CITY OF VANCOUVER

POLICY REPORT DEVELOPMENT AND BUILDING

TO: Vancouver City Council
FROM: Director of Planning
SUBJECT: CD-1 Rezoning - 6111-6161 Oak Street and 1007 West 46th Avenue

DRAWING
 ELEVATIONS

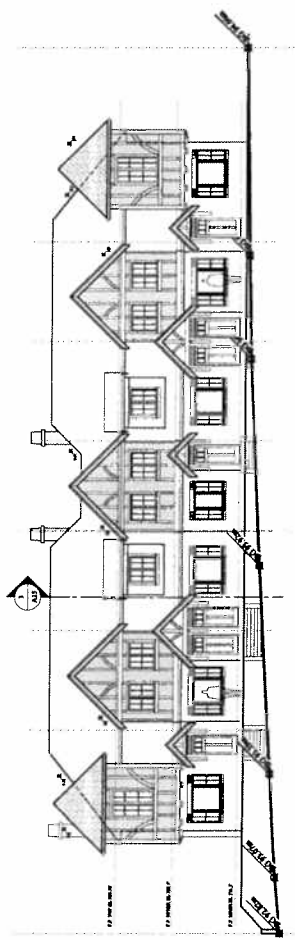
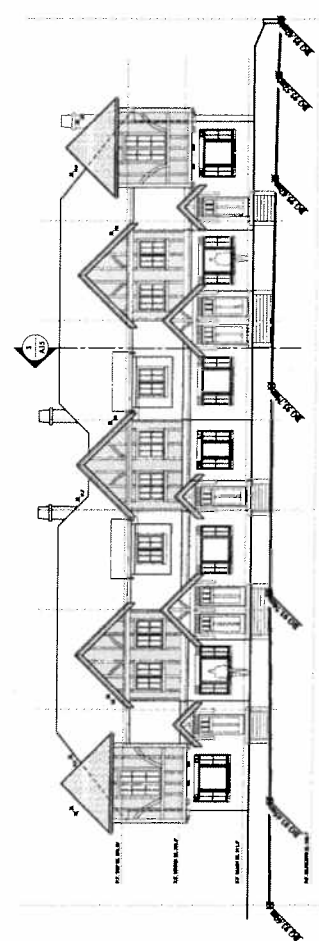
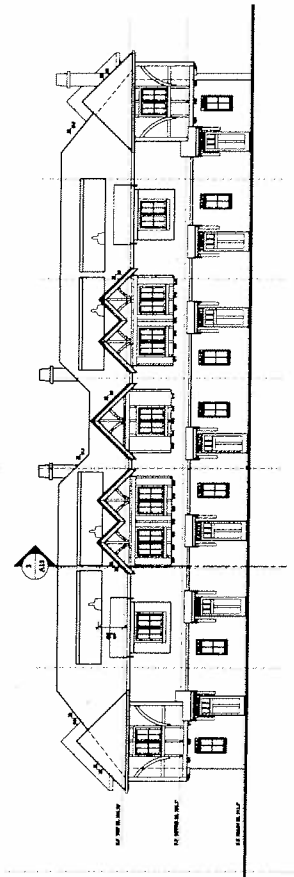
- consider detailing of the landscaping and how the transition will work with the grade change from the entry gardens to the sidewalk level;
- consider a more civic formality for the Oak Street Elevation;
- consideration of the interior space for potentially more social or communal uses; and
- consider more sustainability initiatives.”
